2016 *FIRST*[®] Robotics Competition

Team Updates

Team Update 1

01/12/2016

Figure 3-2: Examples of G18 compliance and non-compliance.

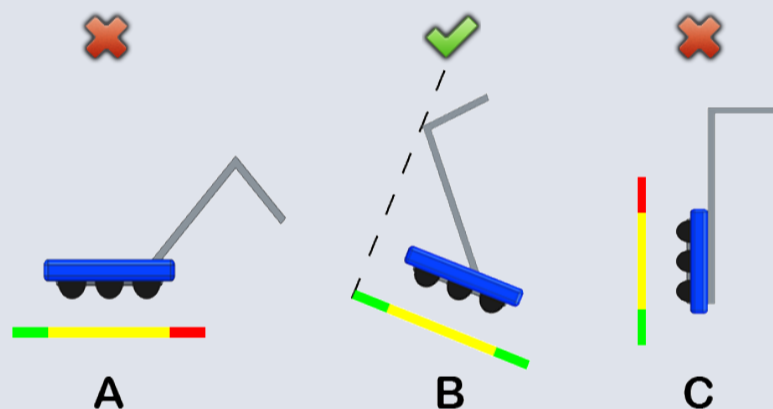
- **G18** ROBOTS may not extend more than 15 in. beyond their FRAME PERIMETER.

Violation: FOUL. If repeated, offending ROBOT will be DISABLED.

Examples of compliance and non-compliance of G18 are shown in Figure 3-2.
